Evaluation and Findings Report

Section 401 Water Quality Certification for the Jordan Cove Energy Project

May 2019

State of Oregon
Department of
Environmental
Quality

Figure 16: Pipeline Crossing at Tributary to Cooston Channel showing no “neckdown” of ROW

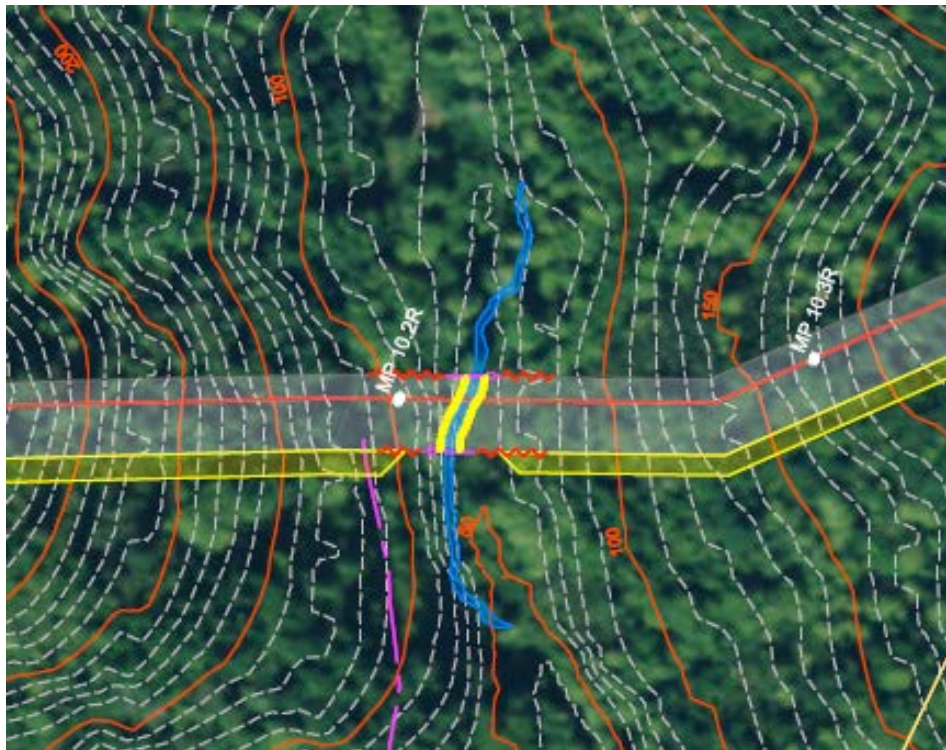
As an illustration of the reasons for DEQ's concerns about the temperature impacts of the proposed Project, at pipeline stream crossing at Milepost 58.78, Ollala Creek is limited for temperature year round and is under an approved TMDL. Similarly, DEQ has placed Rice Creek (Milepost 65.76), South Umpqua River (Milepost 71.27), North Myrtle Creek (Milepost 79.12), South Myrtle Creek (Milepost 81.19), and many others on the 303(d) list for temperature. These streams are under an approved temperature TMDL.

Figure 2 of 47 from PCGP's Geologic Hazards Maps (Northwest of Milepost 8R):

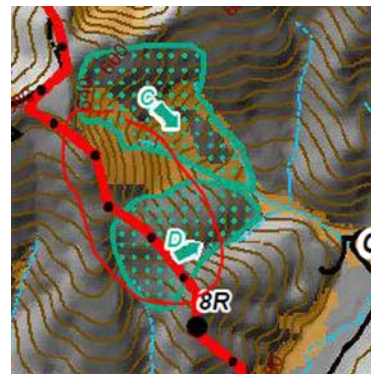
<p>PCGP’s Erosion Control and Revegetation Plan does not indicate if the Temporary Work Area above the unstable slope feature will be used to store spoils (soil, boulders, root wads) and logs from forest clearing. However, PCGP’s Resource Report 1 indicates that PCGP may use these work areas for these purposes. The ECRP does not detail how PCGP will manage construction stormwater above this unstable feature. Stormwater discharge at the top of convergent headwalls and bedrock hollow adds load to the top of this unstable slope. This stormwater discharge may create a positive soil pore pressure leading to a landslide. PCGP has not provided DEQ with an engineered post-construction stormwater management plan for the permanent pipeline right-of-way for this area and others indicating how PCGP will manage drainage above unstable slope features.</p> <p>On page 35 of Resource Report 6, PCGP discusses two primary ways in which pipeline construction has the potential to adversely impact slope stability. PCGP notes in Report 6 that routing drainage to potentially unstable slopes has the potential to adversely impact slope stability. However, PCGP does not provide DEQ with an analysis using the slope stability models to identify unstable slopes noted in DEQ’s review of PCGP’s response to Comments 6 and 7. Additionally, PCGP does not provide DEQ with a construction and post-construction stormwater management plan demonstrating how specifically PCGP will manage stormwater along these unstable landscape features.</p> <p>PCGP only identifies slope breakers along the construction and permanent right-of-way as the only technique to manage construction and post-construction stormwater. PCGP does not discuss, for example, or demonstrate the application of cutoff trenches presented in technical manuals on stabilizing slopes. PCGP does not detail the grade and placement of slope breakers on the ground in engineering plans for the construction and permanent right-of-way. Without this information as well as the drainage pattern, DEQ is unable to determine if the proposed use of slope breakers alone is sufficient to prevent the addition of weight from stormwater and an increase in soil pore pressure on an unstable slope.</p> <p>With the current submittal, DEQ cannot determine if the proposed slope breakers highlighted in the Erosion Control and Revegetation Plan will prevent landslides due to pipeline construction and operation. Additionally, in Resource Report 6 and the proposed ECRP, PCGP does not address site-specific constraints (i.e., roads, unstable landforms on each side of the right-of-way etc.) that may limit the application of slope breakers to route drainage away from unstable slopes. PCGP is proposing to remove trees and shrubs to install this gas pipeline. This loss of tree interception will increase the volume of runoff generated along pipeline’s construction and permanent right-of-way. The discharge of this additional runoff among these unstable slope features has the potential to impact water quality.</p> <p>The following are two more examples highlighting similar concerns discussed in DEQ’s review immediately above.</p>

Figure 2 of 47 (Northwest and South of Milepost 10R) – Area No. 115 delineated in red is an identified landslide from the Department of Geology and Mineral Industries:

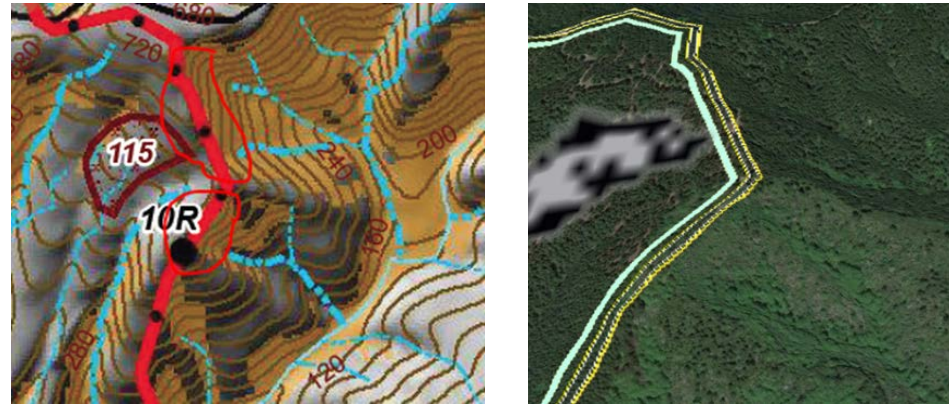
PCGP's ECRP does not show the engineering analysis and its technical support for how PCGP will manage the construction and post-construction stormwater above the Area of a Rapidly Moving Landslide Hazard and convergent headwall as well as the mapped landslide 115 identified by the Oregon Department of Geology and Mineral Industries..

Figure 4 of 47 (Southeast of Milepost 17 BR) – Blue square is a hydrostatic test location while the magenta polygon is an uncleared storage area:

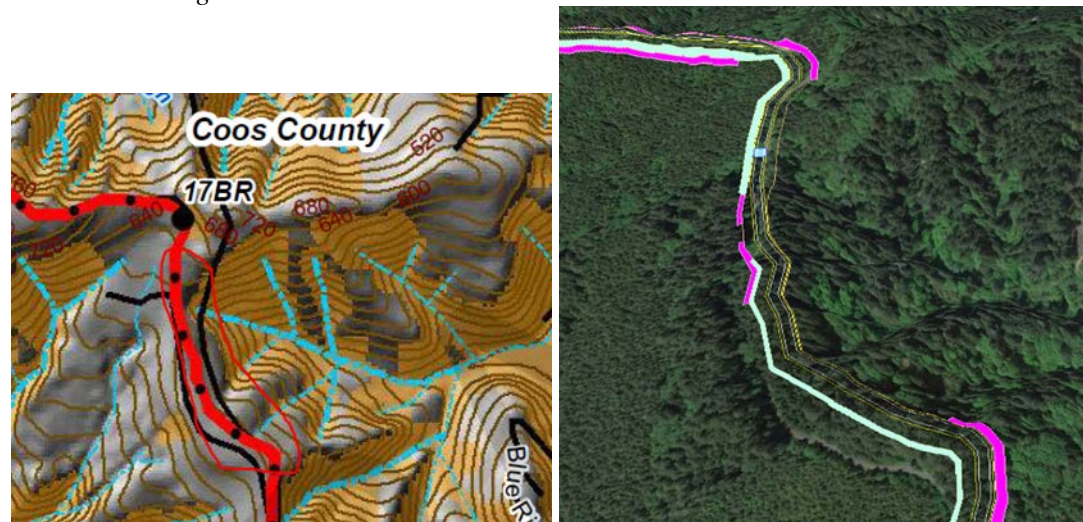
PCGP’s ECRP does not show the engineering analysis and its technical support for how PCGP will manage the construction and post-construction stormwater above the Area of a Rapidly Moving Landslide Hazard and convergent headwall.

Location of TAR 27.06 near Milepost 27 on the General Location Maps. Drawing No. 3430.31-Y-Map 5, Sheet 6 of 55

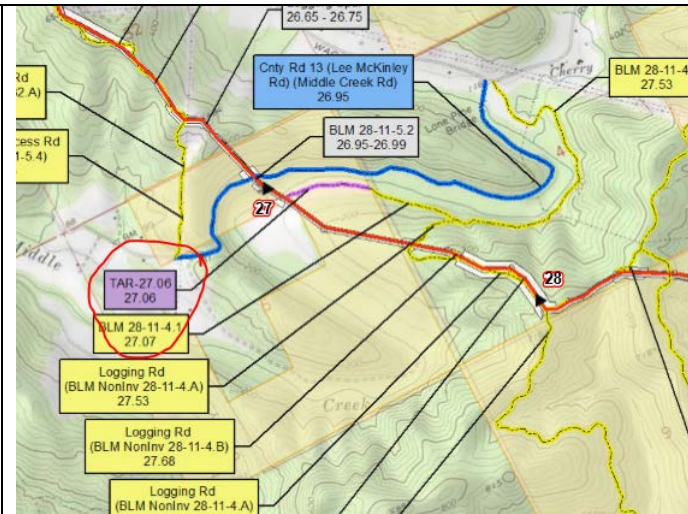
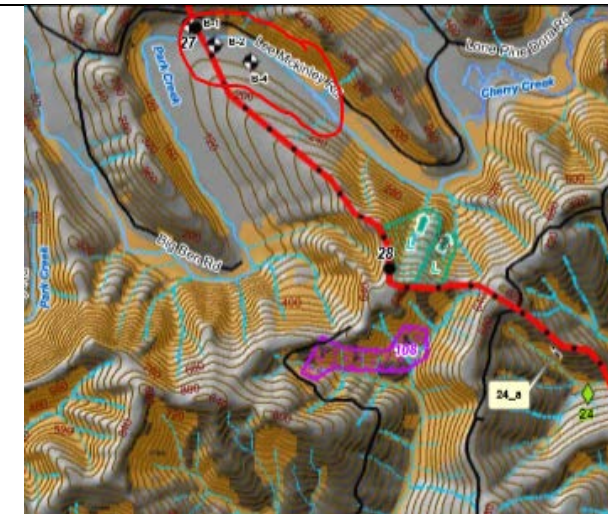
<p>To ensure these roads will not serve as a source of sediment to and hydromodification of waters of the state and as a source of debris flows into streams from road-related landslides, please include the design standards and specifications for constructing these roads including their drainage systems, cut-slopes, and fill-slopes. Please identify the proposed designs to stabilize fill slopes and cut slopes and manage stormwater on new temporary and permanent roads located on the steep slopes (i.e., slopes greater than 30%) and engineering support for these designs. This information is necessary for DEQ to evaluate compliance with the statewide water quality criteria for road building and maintenance (OAR 340-041-0007)(7) and for ensuring that PCGP uses the highest and best practicable treatment control (OAR 340-041-0007(1).</p>	<p>lands. Four waterbodies will be crossed by permanent access roads, and three of those waterbodies are ditches. Appendix A in Part 2 of the 401 Water Quality Package issued to DEQ on February 6, 2018 outlines PCGP’s compliance with all applicable water quality standards and where plans have been developed for the Pipeline to ensure compliance with those standards, including compliance with requirement for TMDLs on federal and non-federal lands.</p> <p>Table A.2-6 is in Appendix A.2 to Resource Report 2 (Attachment C of the PCGP JPA package) lists waterbodies crossed by or within 100 feet of temporary and permanent access roads.</p> <p>PCGP will revise table A.2-6 (Appendix A.2 to Resource 2 – Attachment C of the PCGP JPA package) to identify best management practices for waterbodies crossed by or within 100 feet of temporary and permanent access roads. PCGP anticipates submitting</p>	<p>Without design details and their technical support, DEQ is unable to determine if PCGP is designing new permanent and temporary roads hydrologically disconnected to water bodies by the design of their drainage system. The Oregon Department of Forestry established rules to address drainage from forest roads as highlighted in DEQ’s review of PCGP’s response to Comment 15 above. ODF developed these rules to comply with water quality standards. The design of a road drainage system and a non-paved road surface, for example, influences the level of sediment delivery into water bodies as discussed elsewhere in DEQ’s review of PCGP’s response to AIR-1. Moreover, the location of cut and fill slopes and their design can destabilize slopes and lead to the failure of unstable, landslide prone slopes. As noted elsewhere in DEQ’s review of PCGP’s response, the literature is replete with information demonstrating that linear infrastructure such as roads can cause slope failures leading to landslides and sending debris flows into stream channels. Human-caused debris torrents impact water quality by changing the natural cycles of sediment delivery to stream systems.³⁹</p> <p>PCGP has not provided DEQ with the selection criteria PCGP will use to site proposed new roads to avoid impacts to water quality. For example, PCGP directed DEQ to Table 1.2-2 (Temporary and Permanent Access Roads for the Pipeline). In this table, the Temporary Access Road labeled as TAR 101.70 appears to be on both Private and National Forest Land (Umpqua National Forest). This TAR provides an example of DEQ’s concerns regarding the siting of these new roads. As shown in the following map excerpts below, PCGP has located TAR 101.70 in a Potential Rapidly Moving Landslide Hazard Area when DEQ compares PCGP’s USGS Quad-Based General Location Maps with PCGP’s Geologic Hazards Maps:</p>

Location of PAR-113.66 and the reconstruction of BLM Noninv 32-2-36.A. Drawing No. 340.31-Y-Map 14, Sheet 32, 55

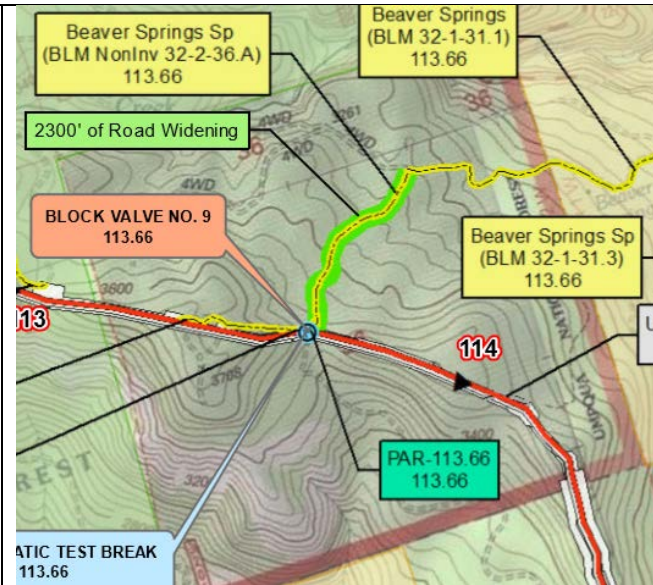
PCGP is proposing to site another proposed new road labeled as PAR-132.66 and shown in the map excerpt below. PCGP proposes to locate this PAR in a Potential Rapidly Moving Landslide Hazard Area. This proposed PAR is also near landslides identified from Aerial Photos and from LiDAR. Moreover, PCGP is proposing to reconstruct BLM's Beaver Springs road (BLM Noninv 32-2-36.A) by widening it. According to PCGP's Geologic Hazard Map, this BLM road identified for widening is located above a landslide area that drains to intermittent stream discharging into Dead Horse Creek. PCGP has not provided DEQ with design information regarding the need for the creation of fill slopes for this proposed new road in an area with unstable slopes. PCGP has not provided DEQ with design information for the reconstruction of the BLM road above unstable slopes. Has PCGP conducted a geotechnical investigation of this road-widening project? If performed, does this geotechnical investigation indicate the need for reinforced fill for this road-widening project? Where will PCGP discharge the post-construction stormwater for this PAR? Given the lack of design details, these questions surface for DEQ while reviewing PCGP's submittal.

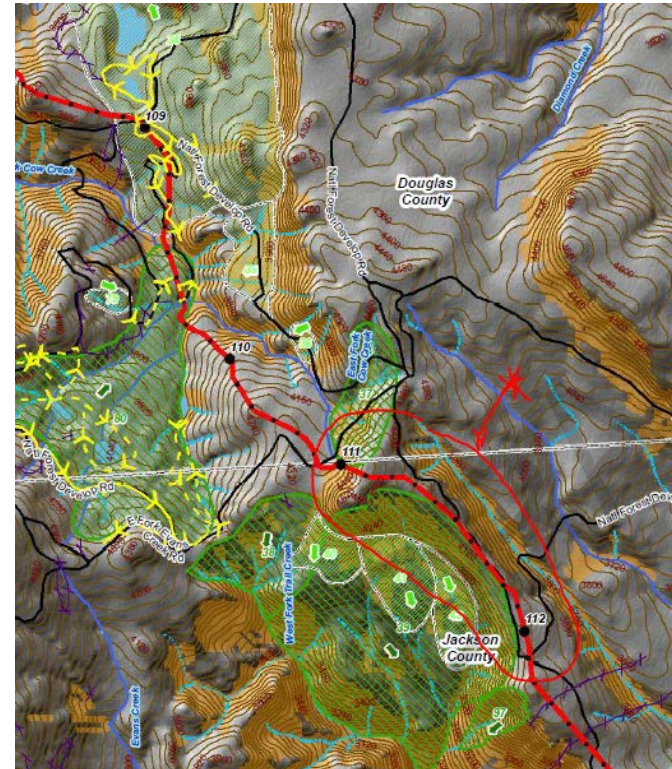
The observations noted in the excerpt above do not address the additional stormwater discharge to this unstable landscape feature particularly above East Fork Cow Creek.

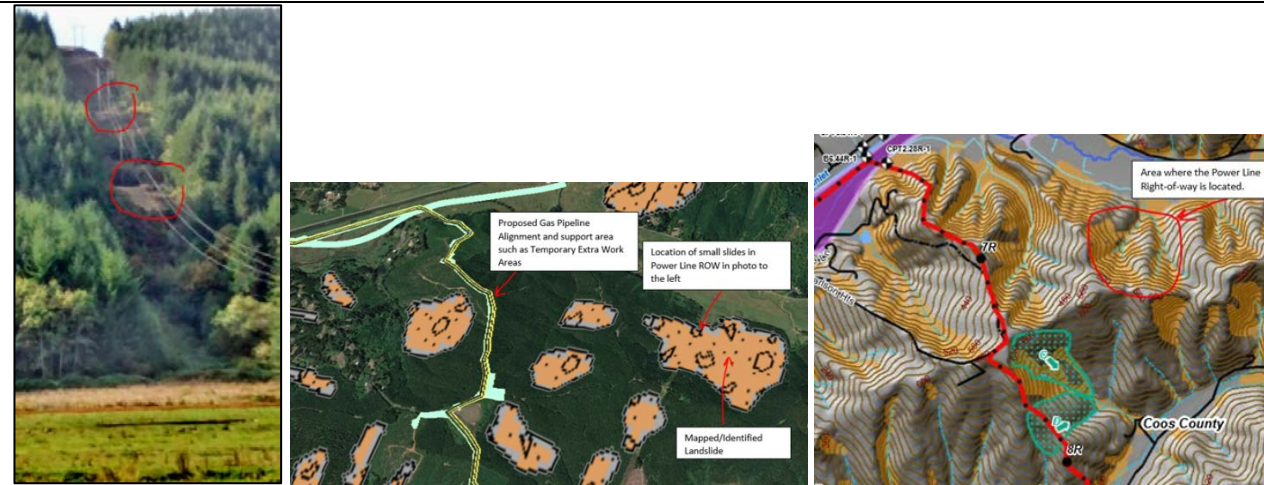
PCGP is proposing to construct and operate a right-of-way for a gas pipeline at many locations with similar site constraints without providing DEQ with engineering designs developed to address site constraints presenting real risks to water quality over time. DEQ's request for the detailed information noted above is essential to demonstrate that PCGP will construct and operate this gas pipeline preventing sediment discharge in stormwater and preventing landslides discharging debris flows into streams.
